UNITED STATES PATENT AND TRADEMARK OFFICE

Office Action Summary	Application No. 10/707,126	Applicant(s) MILLER ET AL.	
	Examiner Michael P. Ferguson	Art Unit 3679

DETAILED ACTION

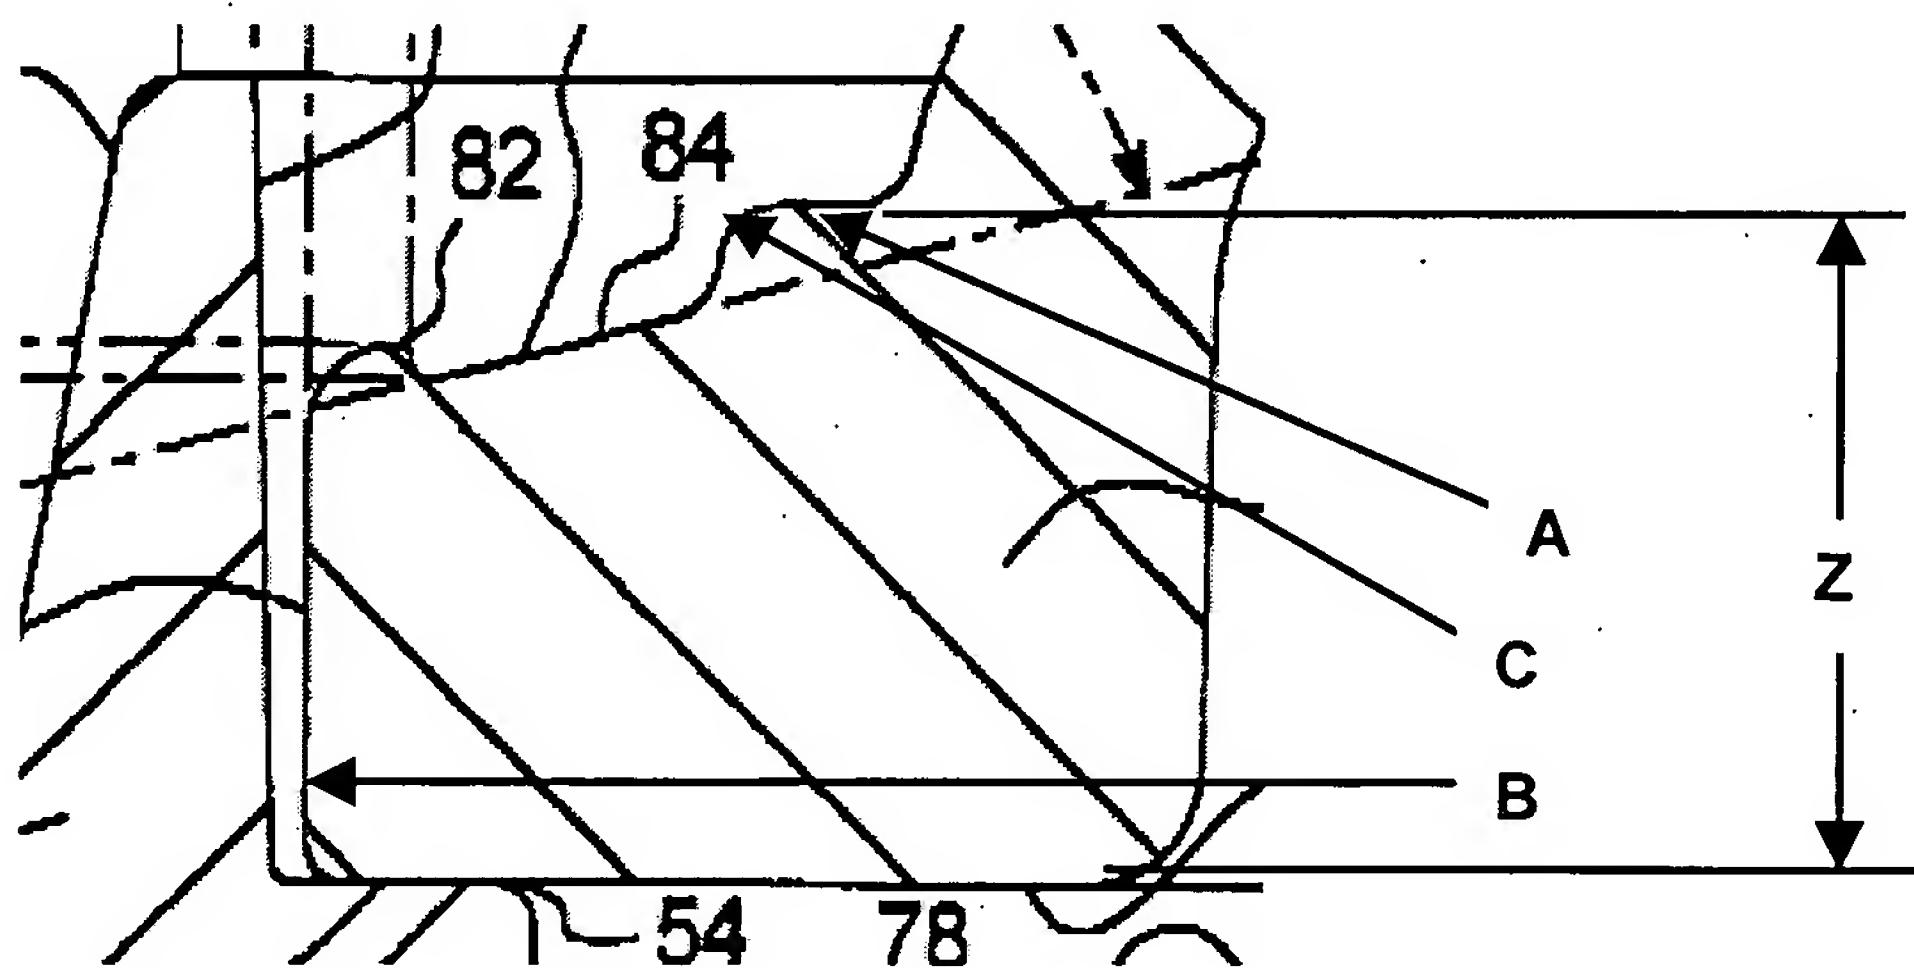
7. Claims 1, 2, 4-6 and 9 are rejected under 35 U.S.C. 102(e) as being anticipated by Morefield (US 6,536,983).

As to claim 1, Morefield discloses a reduced radius hem assembly comprising:
an inner panel **12** (a panel defined by a distinct part of a surface or member)
including an inner surface **A** (Figure 6 reprinted below with annotations) and an outer surface **42** on opposite parallel sides that are spaced apart by the thickness **Z** of (a portion of) the inner panel, the inner panel having an outwardly extending perimeter flange **22** terminating as an end **B** disposed in a first plane, the end having a thickness dimension that is less than the thickness of the inner panel, the inner surface lying in a second plane that is generally perpendicular to the end, and a beveled (slanted) surface

C located between and contiguous with the end and the inner surface, the beveled surface being disposed inboard of the intersection of the first and second planes; and

an outer panel **14** (a panel defined by a distinct part of a surface or member) having a peripheral edge comprising a bend portion, an intermediate portion, and an end portion **66** wherein the intermediate portion is adjacent to the beveled surface of the perimeter flange and the end portion overlies a portion of the inner surface of the perimeter flange (Figures 6 and 7).

As to claim 2, Morefield discloses a hem assembly wherein the thickness **Z** of the inner panel **12** (at portion **Z**) is greater than the thickness of the outer panel **14** (at portion **76**; Figure 6).

As to claim 4, Morefield discloses a hem assembly wherein the perimeter flange **22** of the inner panel **12** is provided with the beveled (slanted) surface **C** that extends across a portion of the perimeter flange (Figure 6).

As to claim 5, Morefield discloses a hem assembly wherein the hem assembly includes areas that define cut lines (cut lines being defined by the surfaces (lines)

separating inner and outer panels **12,14**; Figure 6) and wherein the beveled surface **C** is provided in the areas defining cut lines.

As to claim 9, Morefield discloses a reduced radius hem for an inner sheet form panel that is hemmed by an outer panel, the inner panel **12** having an outwardly extending peripheral flange **22** having a nominal thickness **Z**, the peripheral flange comprising an end **B** that has a thickness that is less than the nominal thickness **Z** of the flange, an inboard surface **A** that is perpendicular to the end, and a beveled (slanted) surface **C** located between and contiguous with both the end and the inboard surface, the beveled surface disposed in a plane that is recessed relative to the end and the inboard surface, the outer panel **14** having a peripheral edge comprising a bend portion, an intermediate portion, and an end portion **66** whereby the beveled surface at least partially receives the intermediate portion of the peripheral edge of the outer panel (Figures 6 and 7).
